Peer Review Strada Enclosures (June 2025)

Supporting Exhibits

The following exhibits are enclosed in support of Fifth Cycle Peer Review Comments. These exhibits also support the simultaneous Peer Review of the Site Plans. The reader is advised to review the Exhibits prior to the text.

Figure 4: Comparison of Pine River Station 1 flows (blue) to model simulated flows (red).

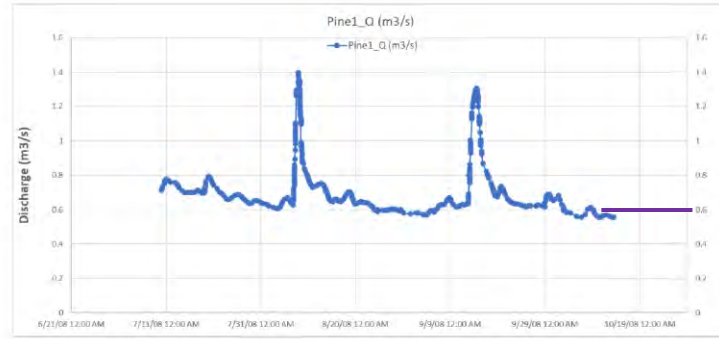
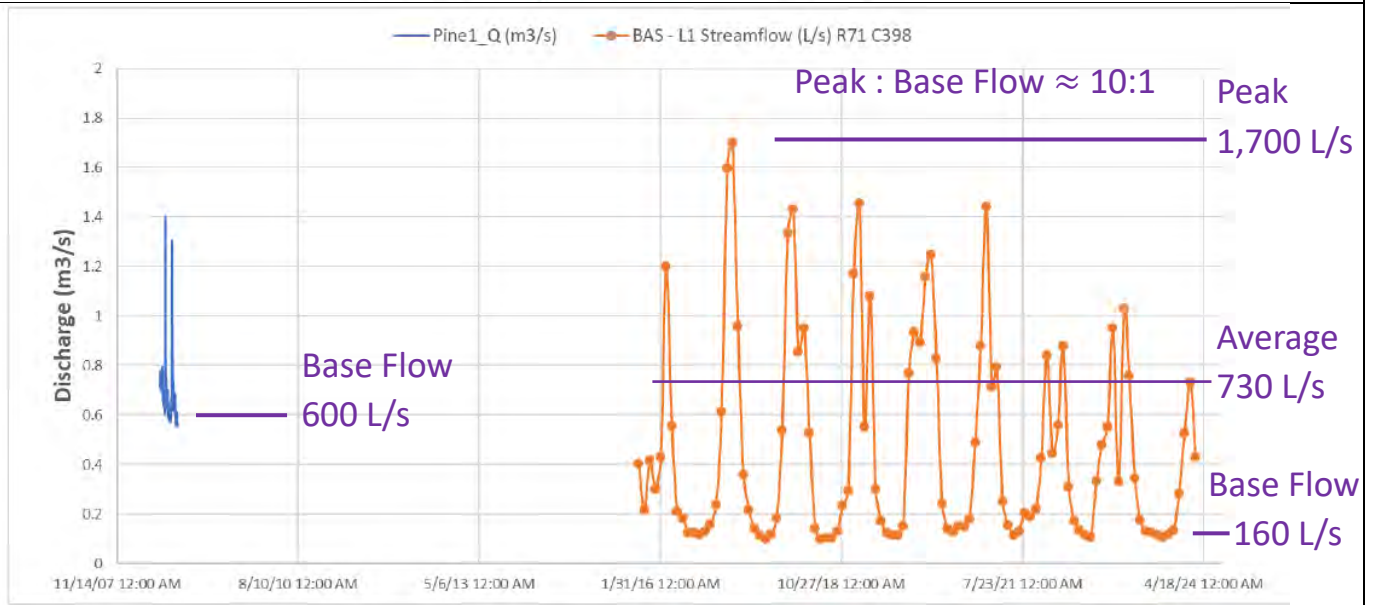
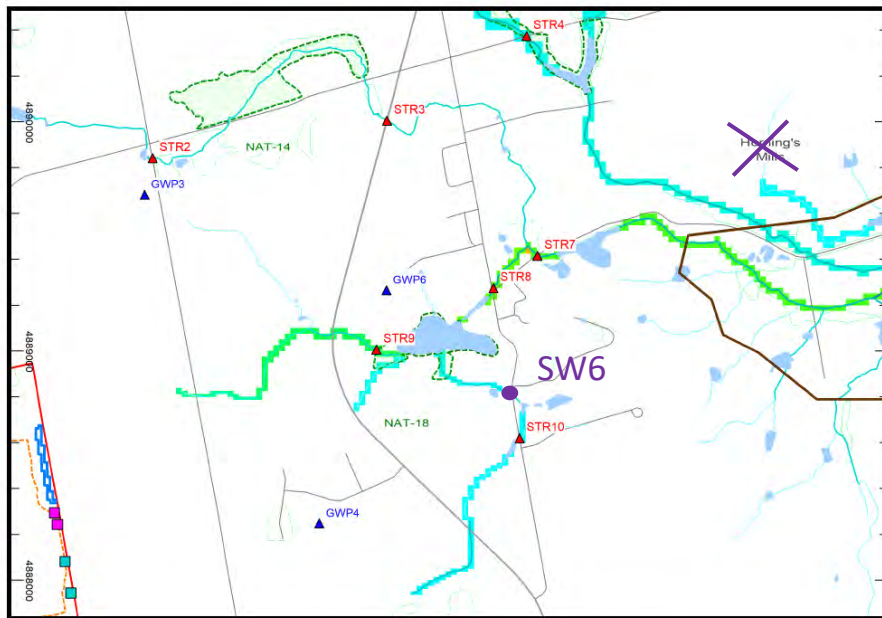
- Ex H.2** Extracts from Earthfx (April 14, 2025) Response to Mediation Questions, Peer Review Amended Fig 2, 4 and 5. (Simulated base flow only 25% of NVCA Pine 1)

Table 2 Monitoring Network including Hydrostratigraphic Layers and Units

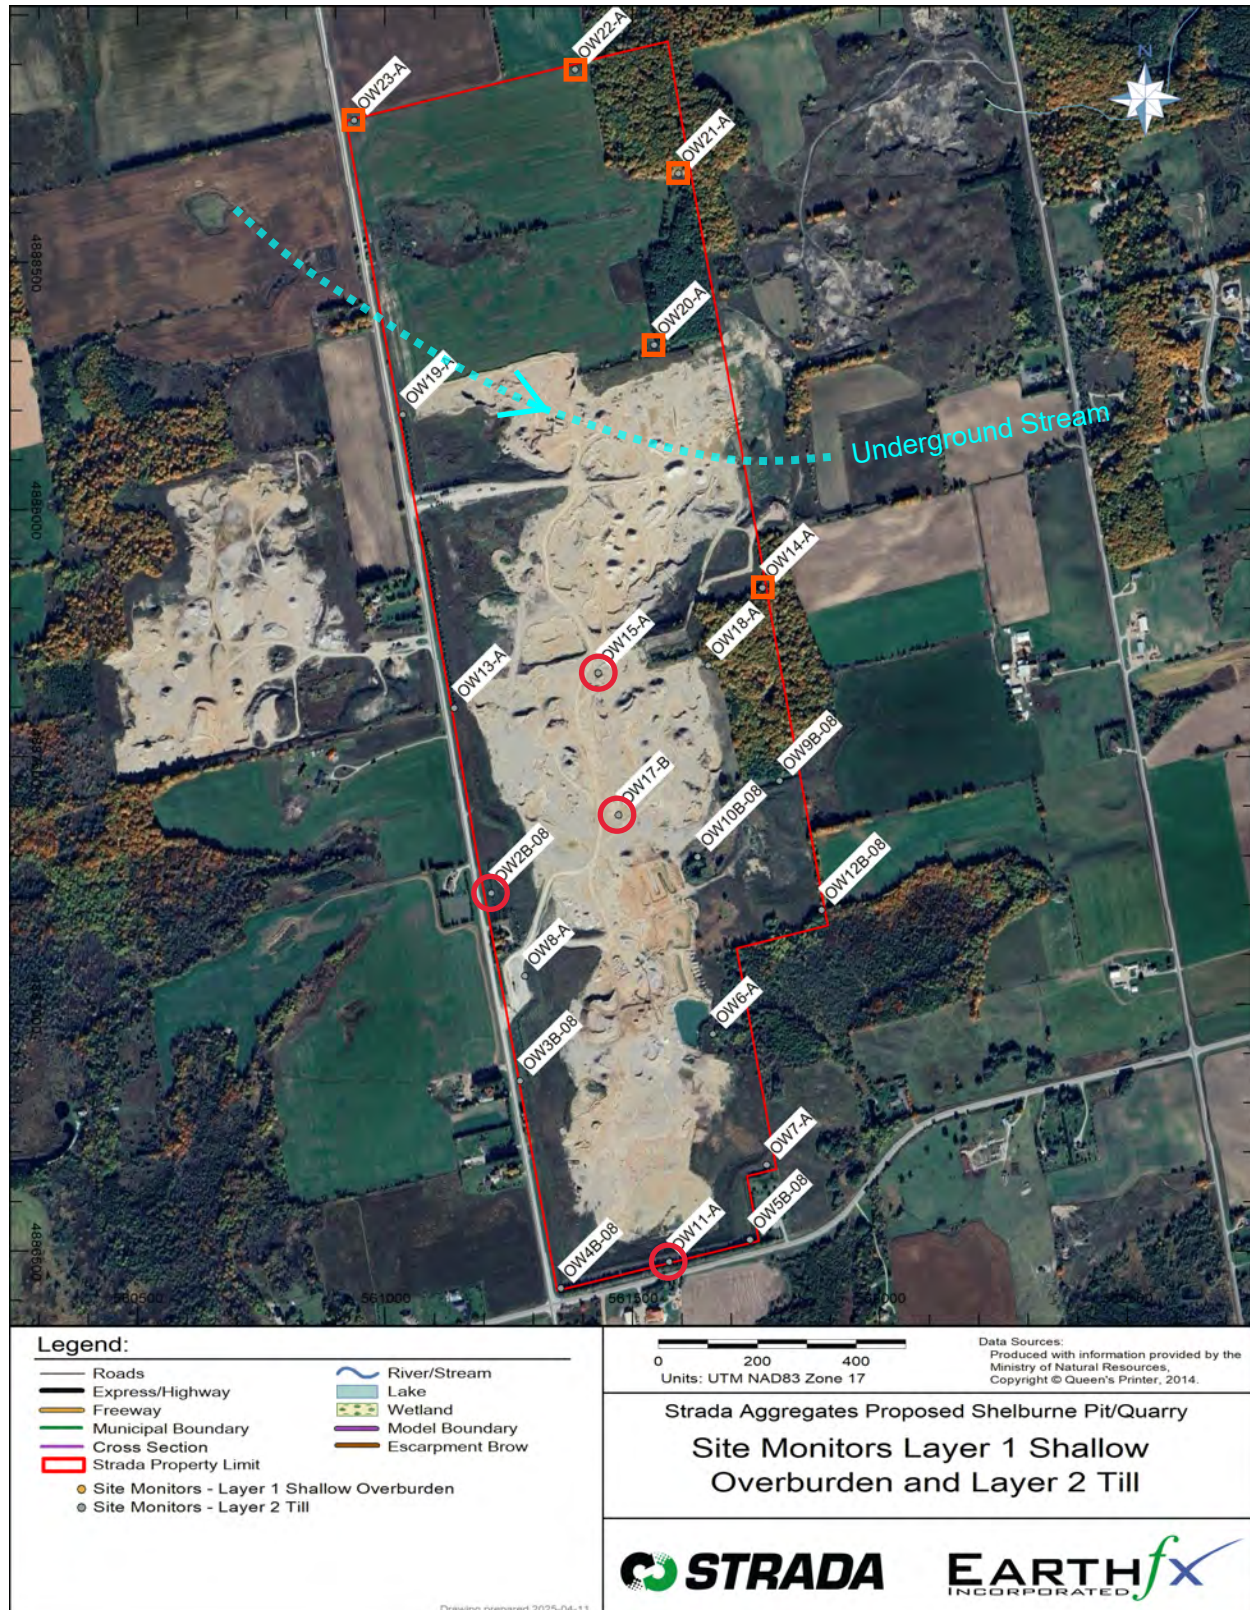
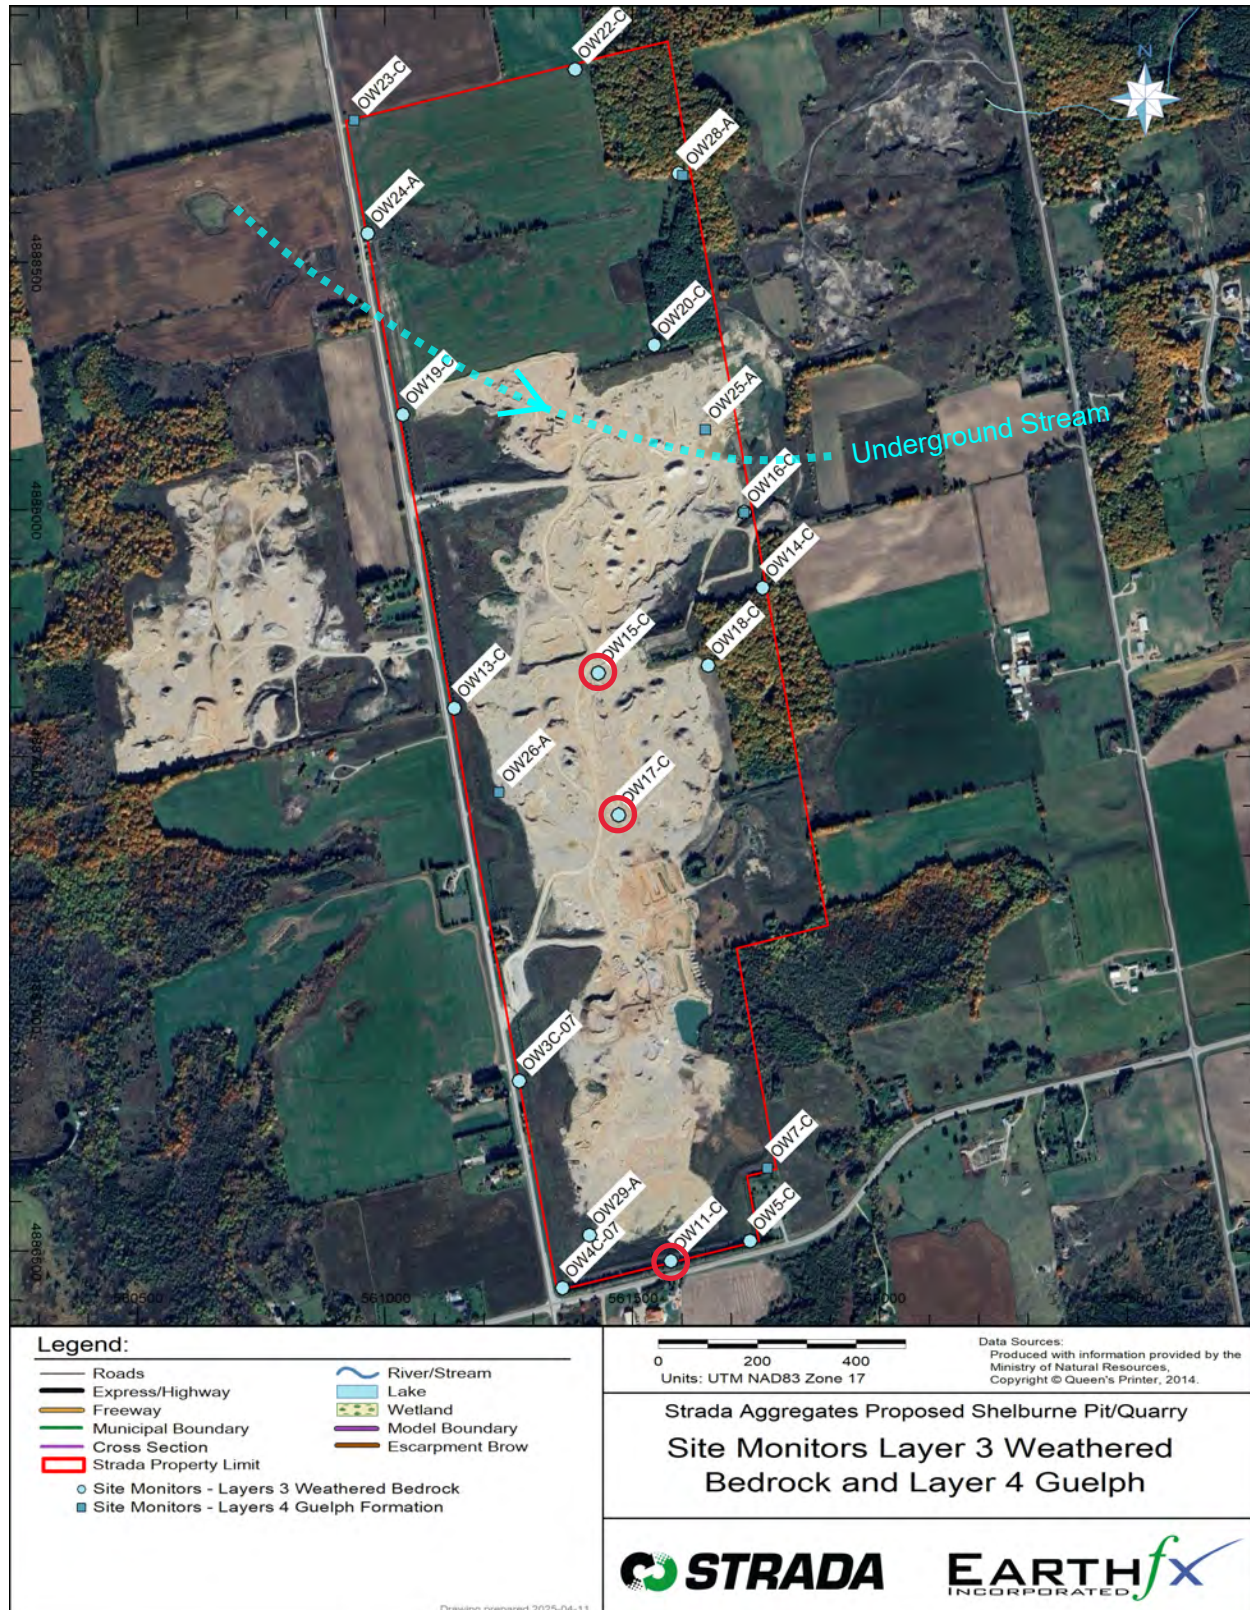
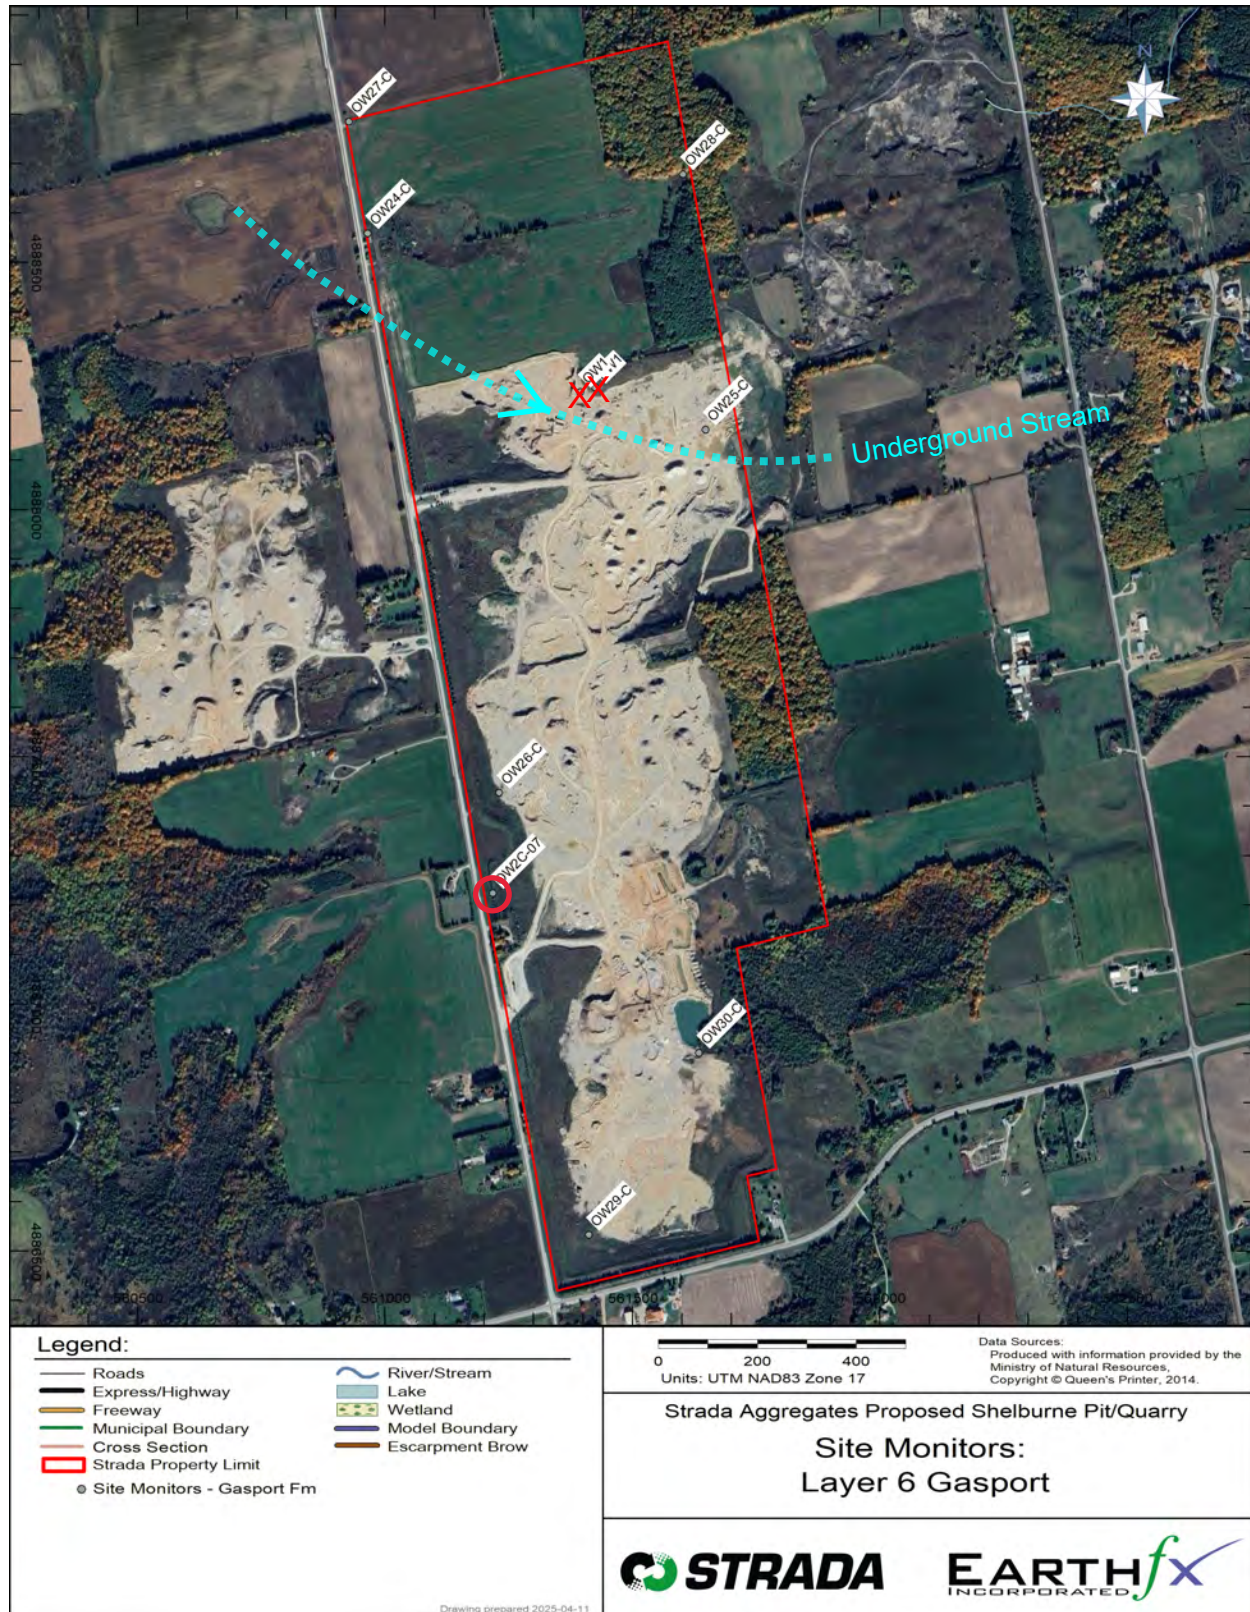
- H.3.2** Model vs Observed Stream Flows
- Ex H.4** Extract from April 14, 2025 Response to Mediation Questions, Peer Review Amended Table 2, Fig 6, Fig 7 and Fig 8 (pg 13 to 17) with Inactive, Destroyed and Dry Monitors.

Figure 3.5: Cross section (elevations in CGVD13) showing Phase 1 extraction

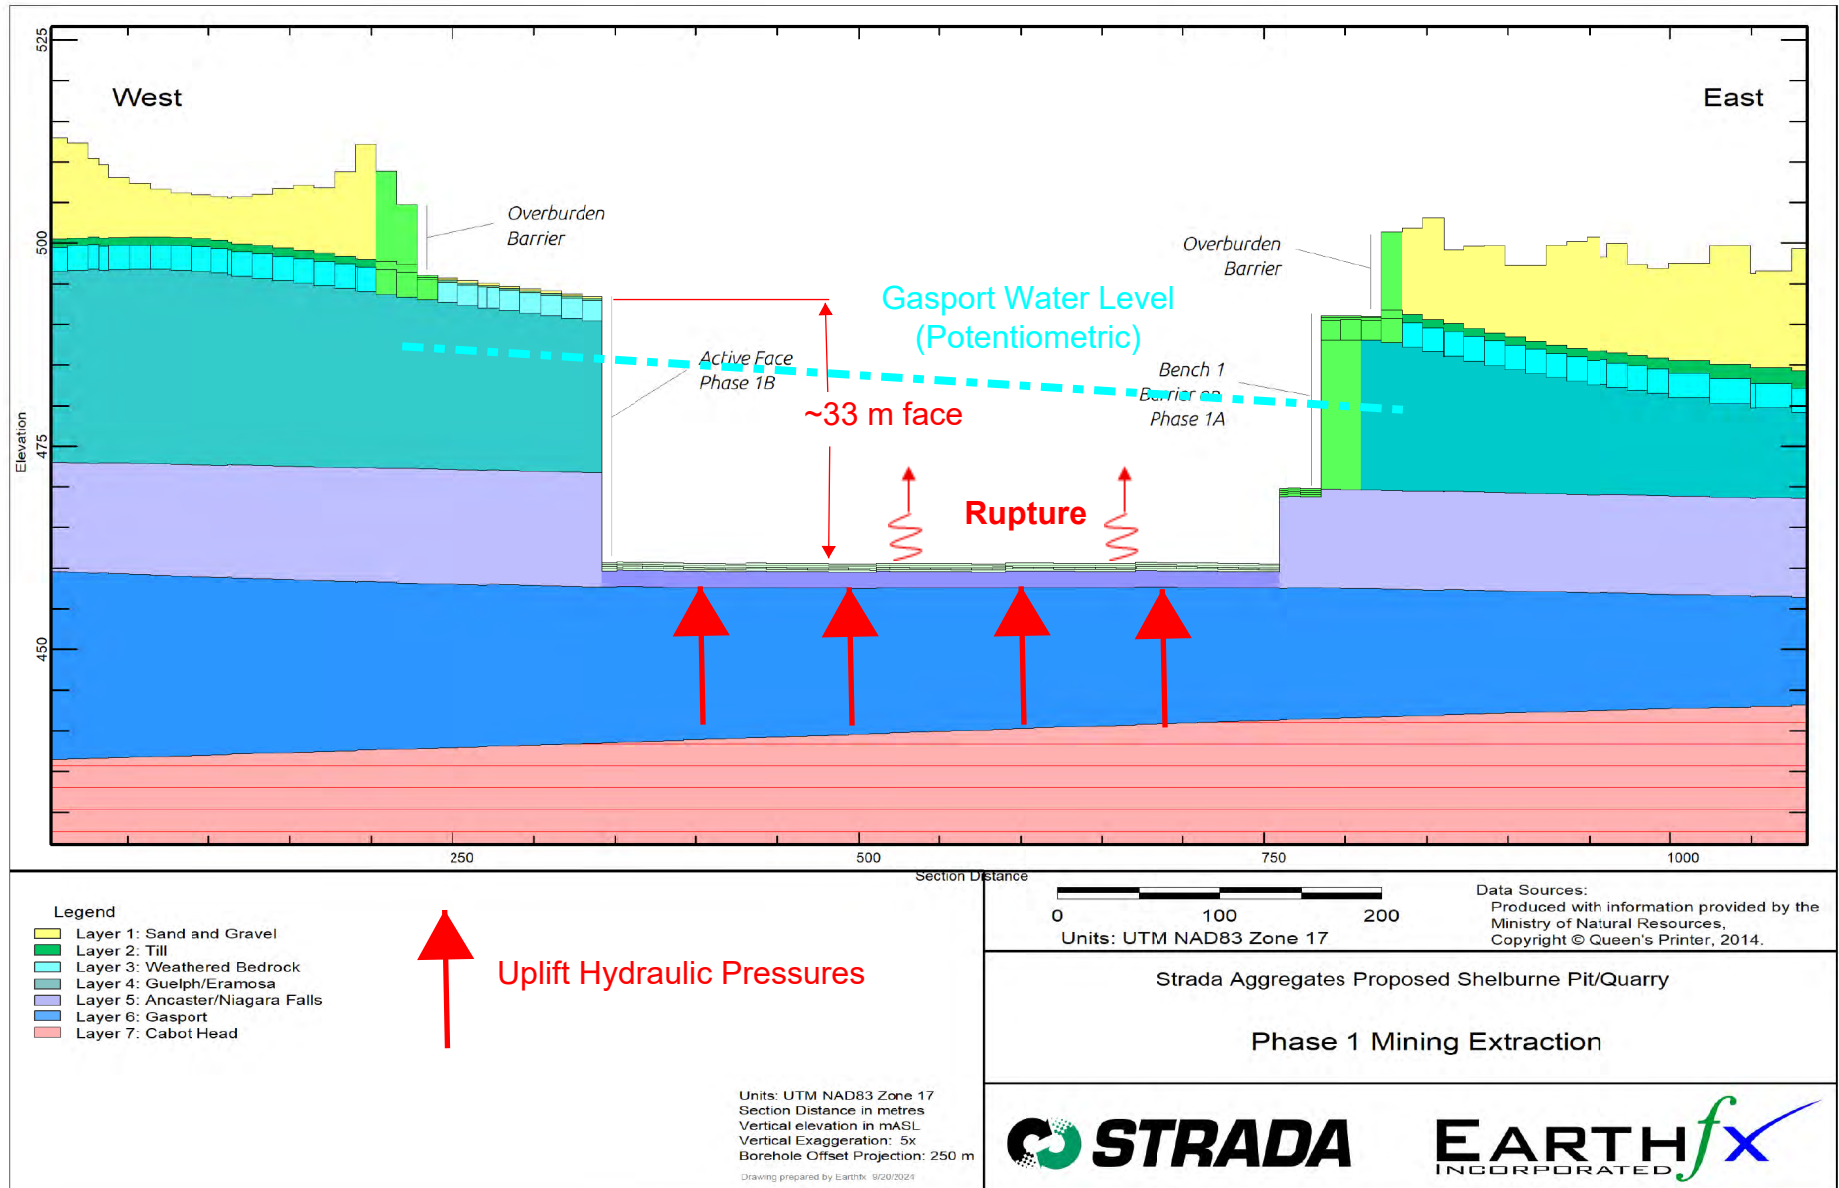
- H.7.1** Pgs 4 to 7 Peer Review Amended Figure.
- H.7.2** Cross Section shows Phase 2 Extraction (Uplift Hydraulic Pressures on Lift 2 Floor)
- Ex H.8** Stormwater Management Fluxes, Excerpts from Appendix E: Impact Assessment January 31, 2025. Only 12 L/s allocated to injection wells.
